UNITED STATES PATENT AND TRADEMARK OFFICE

10/590,176

Office Action Summary	Application No. 10/590,176	Applicant(s) AKIYAMA ET AL.	
	Examiner ERIN D. BISHOP	Art Unit 3655

DETAILED ACTION

Figure A: Fig. 8 of Dalakian, U.S. Patent 5,222,409

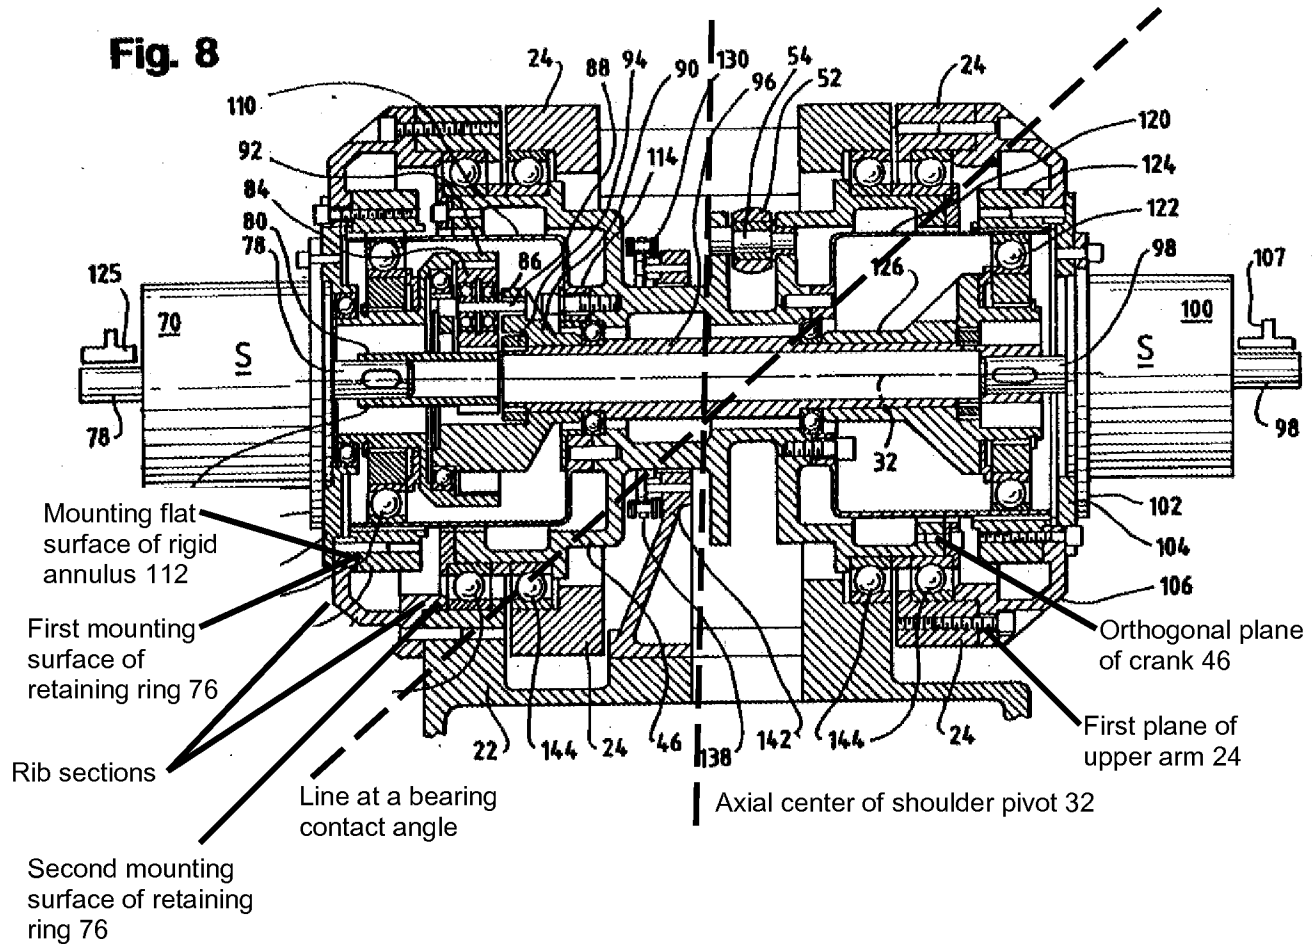
Regarding claim 1, as best understood, Dalakian teaches the claimed turning device (shoulder of robot arm, col. 3, lines 39-41, and fig. 8) for a heavy object (lower arm 26, fig. 2) comprising:

- a rotation output section (crank 46, col. 6, line 40, and fig. 8) having an orthogonal plane orthogonal to the axial line of the turning pivot (orthogonal plane of crank 46, see fig. A below),

the turning arm has a first plane connected to the plane of the rotation output section (first plane of upper arm 24, see fig. A below) and a second plane connected to the heavy object, positioned nearer to the heavy object from the axial line of the turning

pivot and orthogonal to the first plane (second plane of upper arm 24, see fig. B below), and

the turning arm and the drive device are disposed within a width of the turning pivot of the heavy object in the axial direction (upper arm 24 and the shoulder joint drive device are within the axial width of shoulder pivot 32, fig. 8).

the axial center of the turning pivot of the heavy object (axial center of shoulder pivot 32, see fig. A below) is positioned within a distance between one of the pair of ball bearings, which is positioned on the orthogonal plane side of the rotation output section, and an intersection obtained by crossing the axial line of the turning pivot with a line at a bearing contact angle to the perpendicular line of the one ball bearing (line at a bearing contact angle, see fig. A below).

the fixing section of the planetary gear type speed reducer has a circular outside-diameter section (see fig. 8) and a mounting flat surface parallel to the plane of the rotation output section (mounting flat surface of rigid annulus 112, see fig. A below);

a first mounting surface for mounting the mounting flat surface of the fixing section of the planetary gear type speed reducer (first mounting surface of retaining ring 76, see fig. A below),

a second mounting surface for mounting the frame and orthogonal to the first mounting surface (second mounting surface of retaining ring 76, see fig. A below), and

a pair of rib sections for connecting outer both ends of the first mounting surface with outer both ends of the second mounting surface (rib sections, see fig. A below); and

the outside-diameter section of the mounting flat surface of the fixing section of the planetary gear type speed reducer is cut so that its side of the pair of ribs may be shorter than the circular outside diameter (see fig. A below).
